SUBJECT: FINAL RESPONSE TO TASK INTERFACE AGREEMENT 2014-02,
INTERPRETATION OF AMERICAN SOCIETY OF MECHANICAL
ENGINEERS CODE, SECTION XI, TABLE IWB-2500-1, NOTE 1

TASK INTERFACE AGREEMENT 2014-02

ASME CODE, SECTION XI, TABLE IWB-2500-1

NOTE 1 INTERPRETATION

Figure 1 – Side View of RPV Support

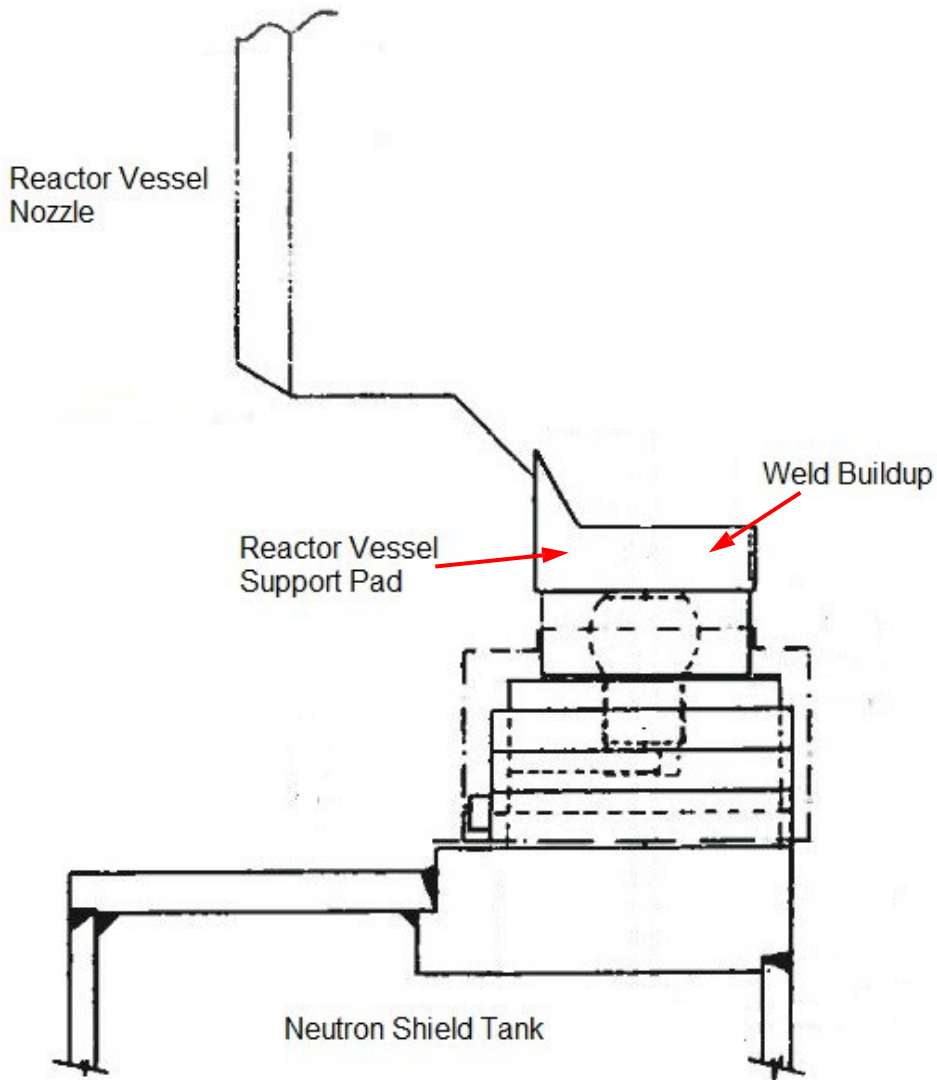
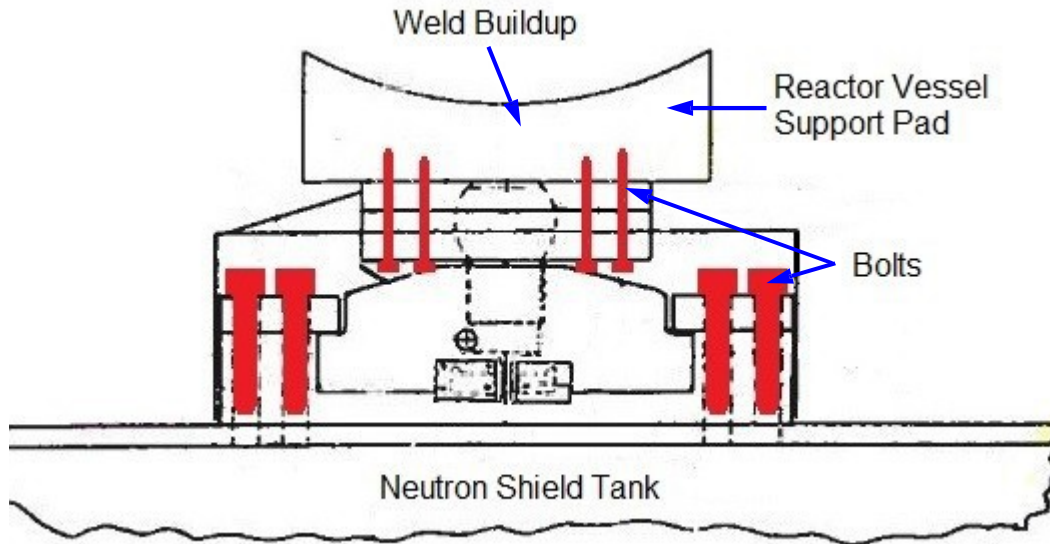
Region II inspectors reviewed design basis calculations and drawings for the Surry, Unit 1, RPV supports, and identified that “normal case” loading conditions on the supports included both compressive and shear loads. The calculations provided in Reference 1, show normal case support loads to be in both vertical compression and horizontal directions. The design drawings showed no attached member to the pressure boundary, as described in Figures IWB-2500-13, -14 and -15. However, the drawings did show a weld build-up on each RPV nozzle, which serves as the attachment point used for the transfer of loads from the nozzle to the building structure.

The ASME BPVC, Table IWB-2500-1, Note 1, states, in part, that a weld build-up on nozzles that is in compression under normal conditions, and provides “only component support,” is excluded from examination. In Surry’s case, the support supplies not only reactor component support, but also serves as a sliding anchor that transfers loads imposed by the reactor coolant system (RCS) piping to the neutron shield tank intervening element, and then to the building structure. The licensee’s calculations clearly show the loads that are supported come from the RCS piping loads and the reactor, not just the reactor component.

The loads imposed on this support location from the RCS piping, which are typically offset by reactor dead weight loads, can only be transmitted to the building support structure through the weld build-up on the reactor nozzle. The support includes a mono-ball assembly mounted to the weld pad build-up by plates, cap screws, and dowel pins. Through additional plates, and the threaded end of the monoball, the support is also provided with vertical hold down plates for any upload case. This arrangement transfers RCS piping loads and reactor loads to the intervening elements of the neutron shield tank, which are then resolved to the building structure. This configuration makes the weld build-up, screws, and dowel pins mounted to it, part of the support load path that will induce tensile and horizontal loads in the nozzle weld build-up pad, and the RCS nozzle pressure boundary, under certain load conditions. The load tables in Reference 1 provide loads consistent with this configuration. Figures 1 and 2 provide a general sketch of the RPV support configuration.

The support under discussion is used in the licensee's calculations (Reference 1) as a support for the reactor vessel, and is also used as a sliding anchor type restraint to transfer loads imposed by the RCS piping through the weld build-up, and other support assembly members, to the neutron shield tank upper surface components and ultimately into the building structure. The support provides four directions of restraint; two vertical directions and two horizontal directions and along with associated moments, and is typically referred to as a sliding anchor support.

Reference 1, Table 6.1.1, provides load tables showing both a vertical compressive load maximum of 290.5 kips, and maximum shear load of 16.59 Kips, not just a compressive load under normal conditions, as described in IWB-2500-1 Table, Note 1. Likewise, Table 6.1.2, "Surry Unit 1 & 2 Deadweight Loads," provides a vertical load of 81.44 kips compressive load, and a 6.32 kips shear load due to the connected RCS piping. [Note that these loads are not component support loads caused by supporting the reactor component itself, as is described by Note 1 of the ASME Table IWB 2500-1.]

1. Contrary to the requirements of IWB-2500-1, Note 1, the Reference 1 calculation provided by Dominion includes horizontal loads under normal load conditions, and includes loads imposed by the RCS piping, not just the loads imposed by the reactor vessel component.

Please provide the NRR position on the acceptability of using Table IWB-2500-1, Note 1, as the exclusion criteria basis for not performing the prescribed surface examination of the weld

build-up to reactor nozzle outer surface; when the weld build-up configuration is as described above for the Surry sliding anchor support configuration.

It is the position of NRR staff that it is acceptable to use Table IWB-2500-1, Note 1, as the exclusion criteria basis for not performing the prescribed surface examination of the weld build-up to reactor nozzle outer surface; when the weld build-up configuration is as described above for the Surry, Unit 1, sliding anchor support configuration, when the stress due to a horizontal shear force does not exist or the conditions (a) through (d) in Note 1 are not met.

The reactor vessel support for Surry, Unit 1, does not have an attachment weld that joins an attachment directly to the surface of the component or integrally cast or forged attachment to the component. Therefore, a surface exam is not required. To consider the significance of not performing a surface examination of this support, the NRR staff determined the maximum tensile stress intensity due to the shear load to be 389 psi based on Reference 1, Table 6.1.1. This is compared to the Pm +Pb allowable for SA-302 Gr. B in accordance with ASME BPVC Subsection NF, 1998 Edition. The allowable is 34,350 psi. This load is negligible even if it were cyclic.

The NRR staff finds that a surface exam is not required, as the reactor vessel support for Surry Unit 1, does not have an attachment weld that joins an attachment directly to the surface of the component or integrally cast or forged attachment to the component. The comment in the meeting notes refers to the protocol used by the ASME Code Committee in addressing inquiries.
